Access Compliance Report

Public Rights-of-Way (Curb Ramps)

Intersection ID: 10014712	Main Street: NORLAND_RD	Cross Street: N/A	Location:	N
ADA ID: 23D556704A2F	Ramp Type: PerpDiag	Initial Pass/Fail: Fail	Overall Compliance: No	Severity Score: 12.5
Codes/Mitigation Info/Possible Solution		Field Measurements/Component Compliance

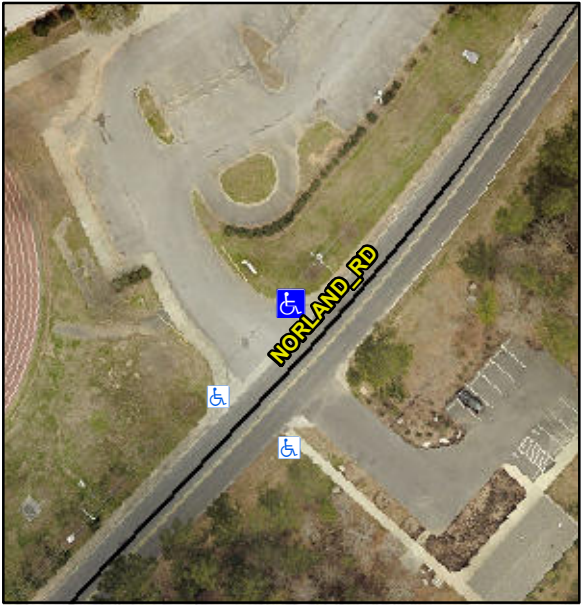
Possible Solutions:						
	Remove & Replace Curb Ramp With Two New Directional Ramps or Equivalent.	Compliance	Description	Data	Compliance	Description	Data
<p>Surveyor Notes:</p> <p>N/A</p> <p>PROW/ADA:</p> <p>R304.2.2</p>		N/A	Ramp Length (in)	47.0	No	Ramp Slope (%)	10.6
		Yes	Ramp Width (in)	49.0	Yes	Ramp XSlope (%)	1.3
<p>Street 1 Name</p> <p>ENTRANCE</p> <p>Stop Condition-Street 2</p> <p>None</p> <p>Street 2 Name</p> <p>NORLAND RD</p> <p>Stop Condition-Street 1</p> <p>None</p>		N/A	Flare Type LT	N/A	N/A	Flare Type RT	N/A
		N/A	Flare Slope LT (%)	N/A	N/A	Flare Slope RT (%)	N/A
<p>Total Cost:</p> <p>\$ 3200.00</p>		N/A	Flare Traversable LT?	N/A	N/A	Flare Traversable RT?	N/A
		N/A	Landing Length (in)	N/A	N/A	DWS Provided?	N/A
		N/A	Landing Width (in)	N/A	N/A	DWS Contrast?	N/A
		N/A	Landing Slope (%)	N/A	N/A	DWS Length (in)	N/A
		N/A	Landing X Slope (%)	N/A	N/A	DWS Full Width?	N/A
		N/A	Landing Curb? (Y/N)	N/A	N/A	DWS Offset (in)	N/A
